STAFF RECOMMENDATION

1401 Lillian Street
May 15, 2019

Application: New Construction—Addition and Outbuilding
District: Lockeland Springs-East End Neighborhood Conservation Zoning Overlay
Council District: 06
Base Zoning: R6
Map and Parcel Number: 08313031900
Applicant: Christian Noble, Noble Johnson Architects
Project Lead: Sean Alexander, sean.alexander@nashville.gov

<p>Description of Project: A proposal to enlarge an historic house with a ridge-raise and rear additions, and to construct a one and one-half-story outbuilding. The outbuilding may be used as a Detached Accessory Dwelling Unit.</p> <p>Recommendation Summary: Staff recommends approval of the proposed New Construction—Addition and Outbuilding with the conditions:</p> <ol style="list-style-type: none">1. The window and door selections and roof colors shall be administratively approved; and2. A restrictive covenant for the DADU shall be filed before the building permit is issued. <p>With those conditions met, staff finds that the proposal meets the design guidelines for the Lockeland Springs-East End Neighborhood Conservation Zoning Overlay.</p>	<p>Attachments A: Photographs B: Site Plan C: Floor Plans D: Elevations</p

DEMOLITION - ROOF

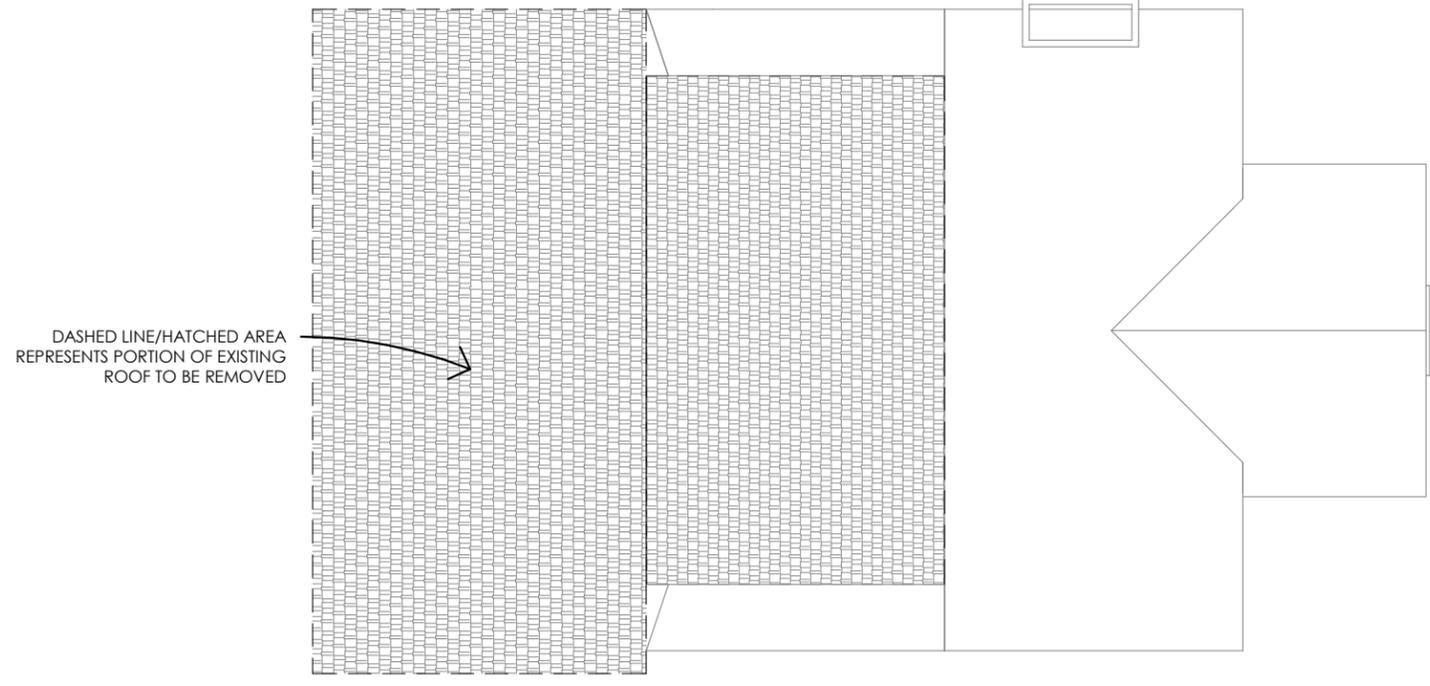
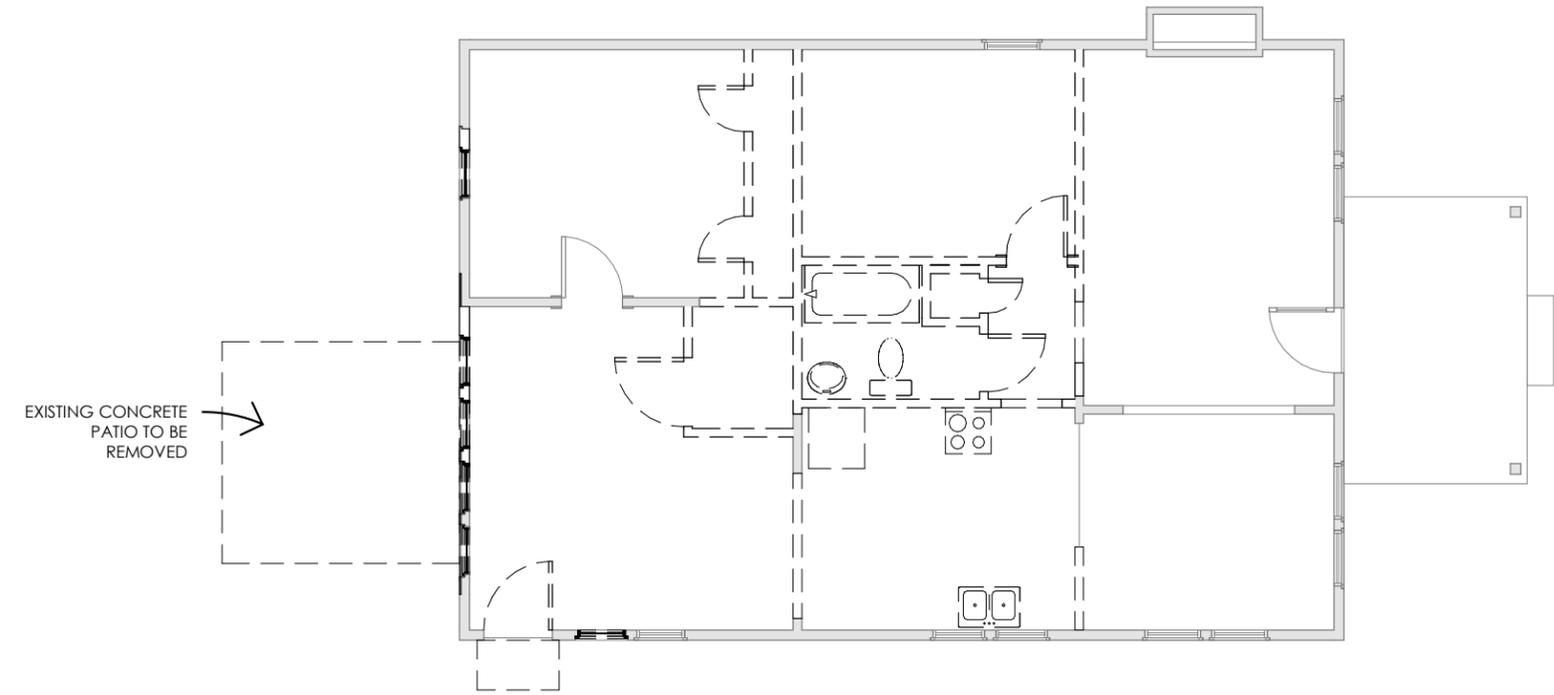
Demolition: The proposal includes demolition of a portion of the existing rear addition and the rear slope of the roof. Although visible because the house is on a corner lot, these elements are not significant to the historic character of the building.

A door and a window on the left side of the earlier addition to the house will be filled in. Because these features are not original, they do not contribute to the historic character of the house.

The non-historic metal carport at the rear of the lot will also be demolished.

Staff finds that the elements to be demolished do not contribute to the historical character and significance of the property, and that their demolition meets Section III.B.2 for appropriate demolition and does not meet section III.B.1 for inappropriate demolition.

sheet title
 ROOF PLAN

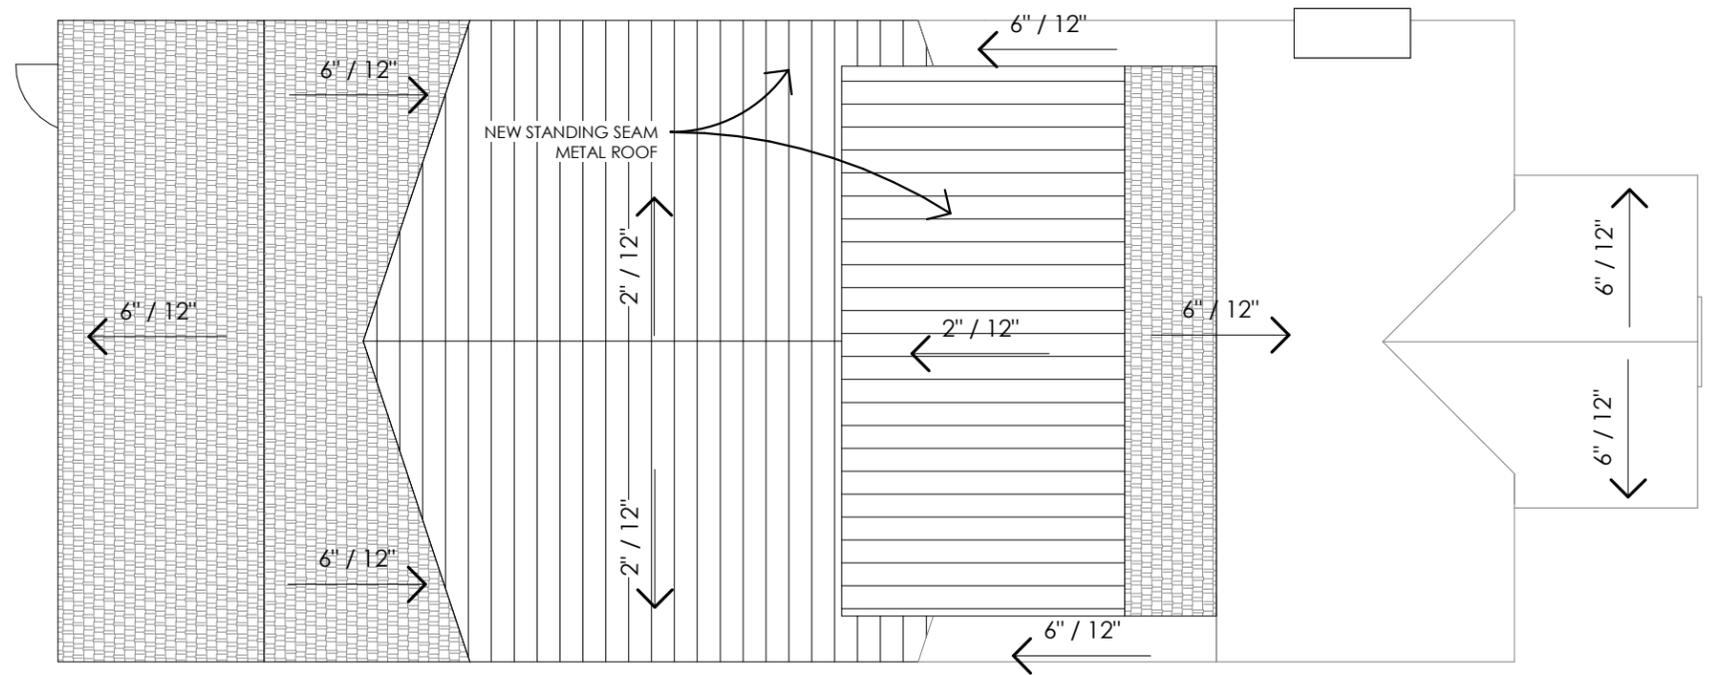
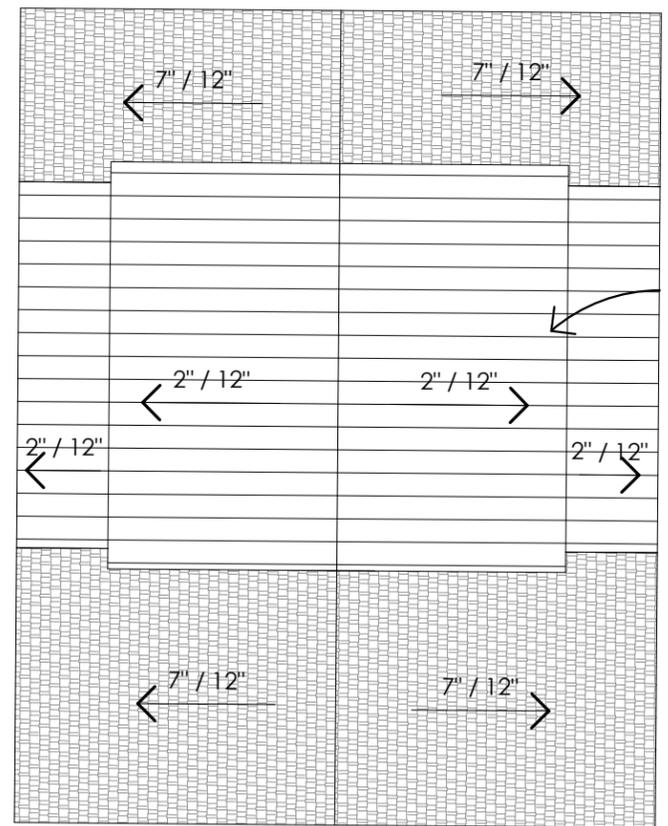
Roof form: The addition includes a shed-roofed rear dormer with a 2/12 pitch, and a side-oriented gable at the rear with a 6/12 pitch to match the original roof. A low-sloped ridge will connect the new side-gabled component to the rear of the existing building.

Staff finds that the roof forms of the addition are compatible with the historic house and will meet Section II.B.5. of the design guidelines.

issue date
 05.03.2019
 sheet title
 EXTERIOR ELEVATIONS

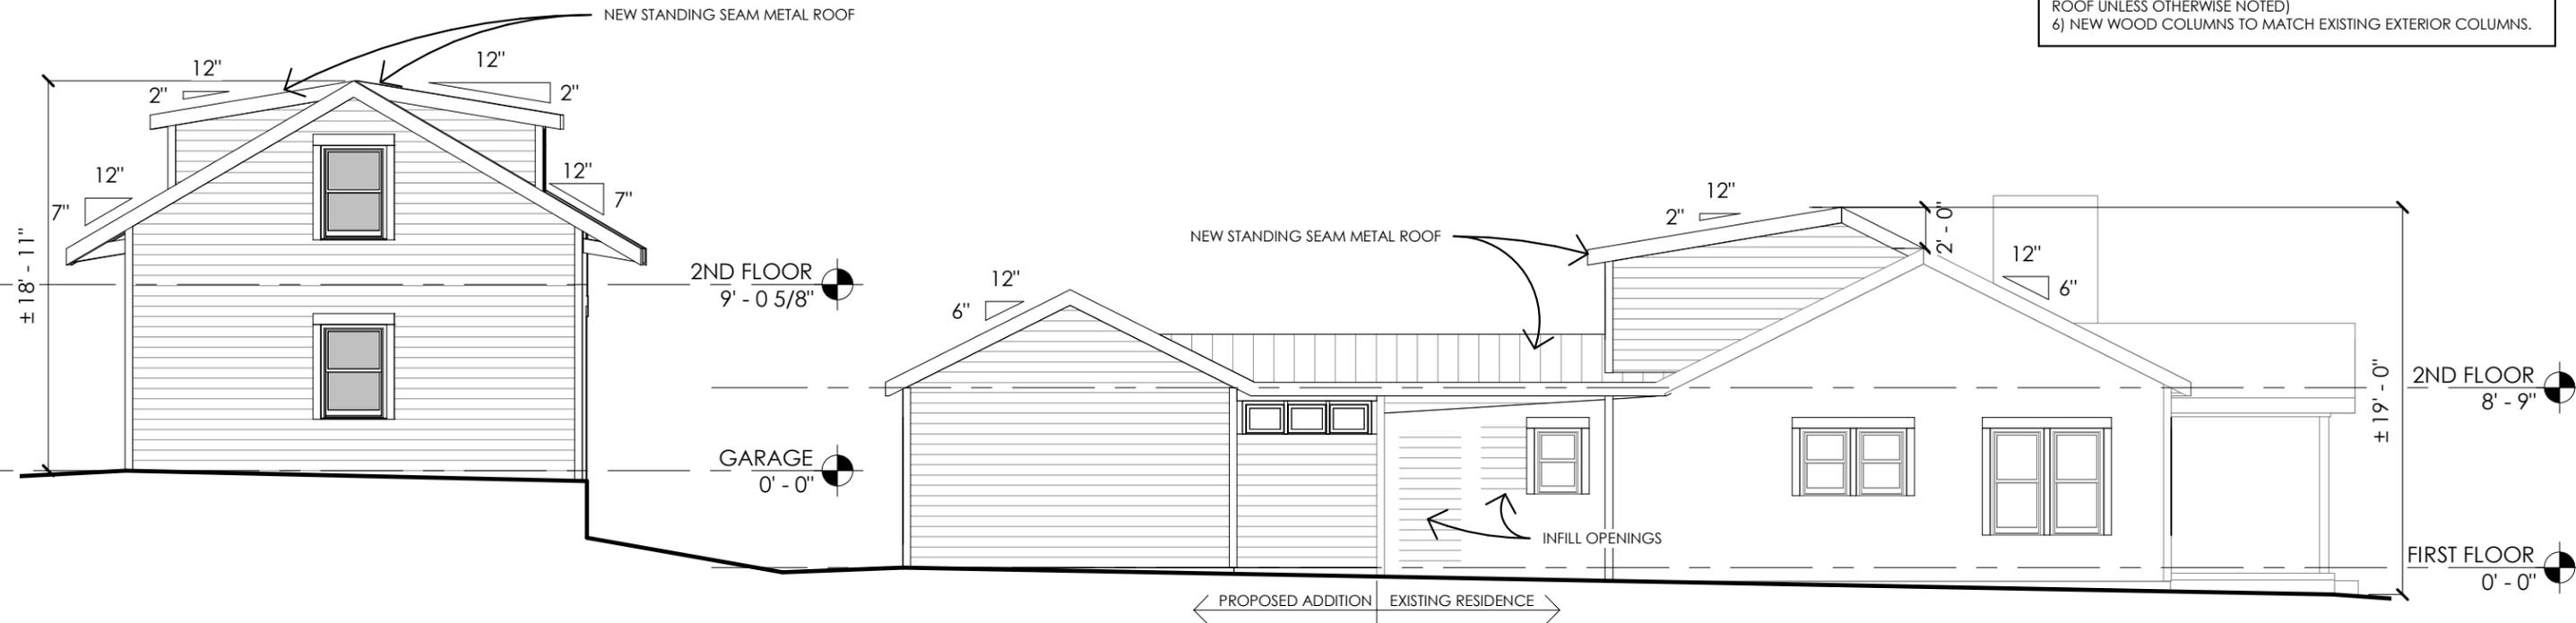
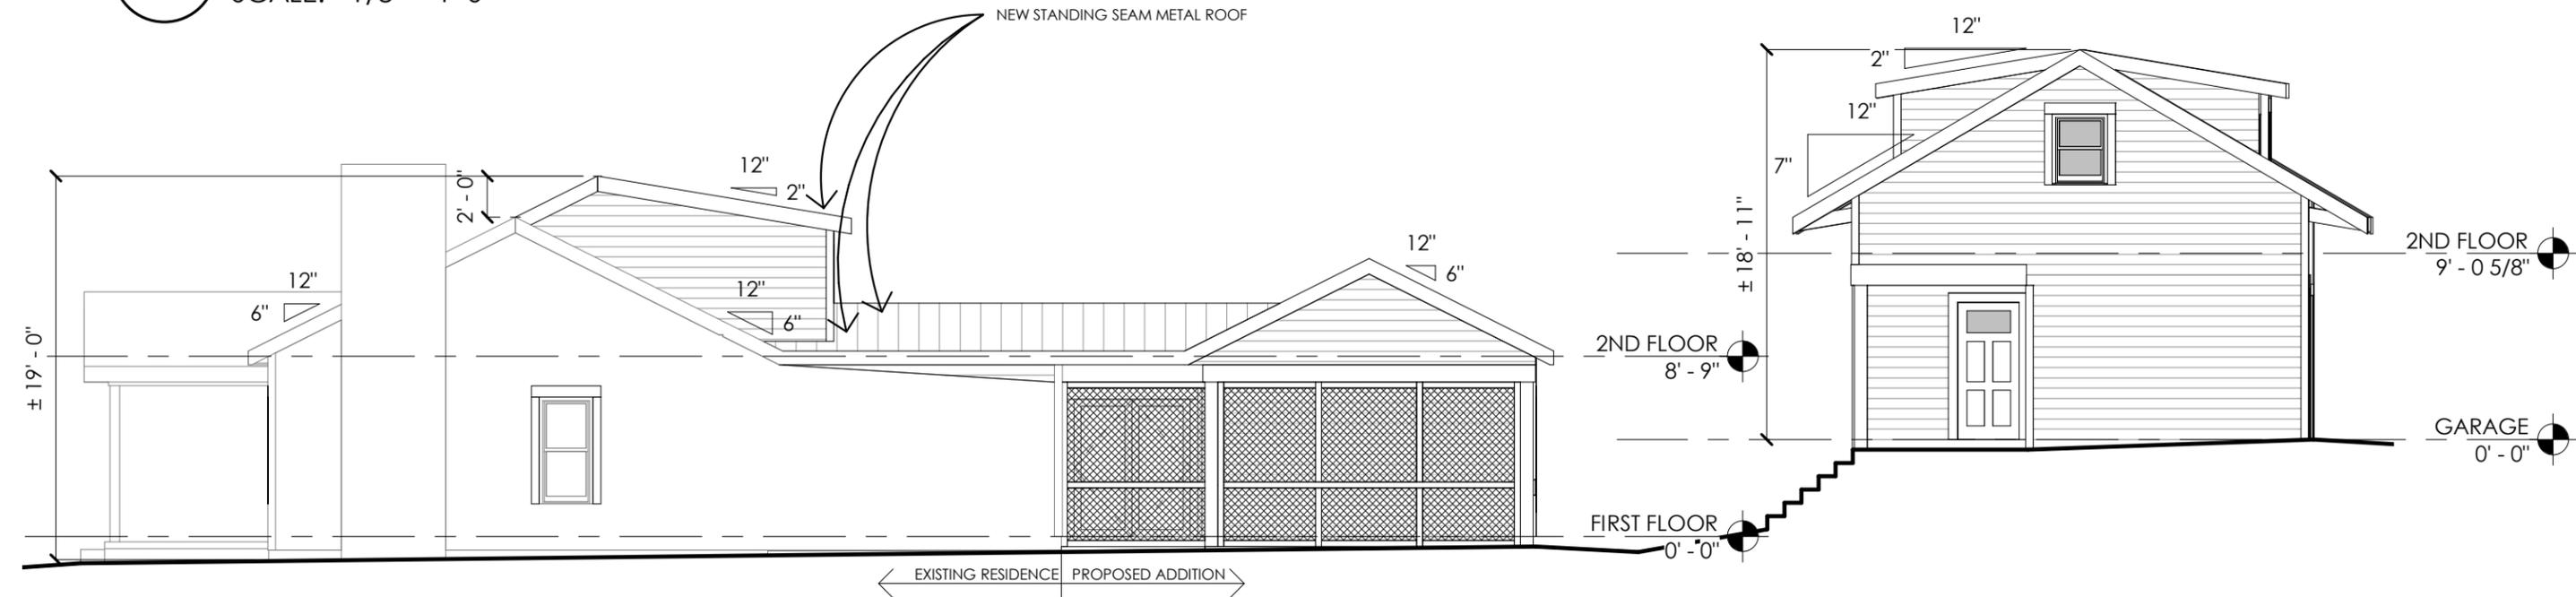
Proportion and Rhythm of Openings: The addition is shown as not having windows in the new side-gabled component, and with a series of small, square windows in the inset portion of the

wall. Typically, new construction is required to have a window opening approximately every ten to twelve feet (10' – 12') of wallspace.

With a condition that a window is added on the left side of the gabled component, staff finds the rear addition's proportion and rhythm of openings will meet Section II.B.7. of the design guidelines.
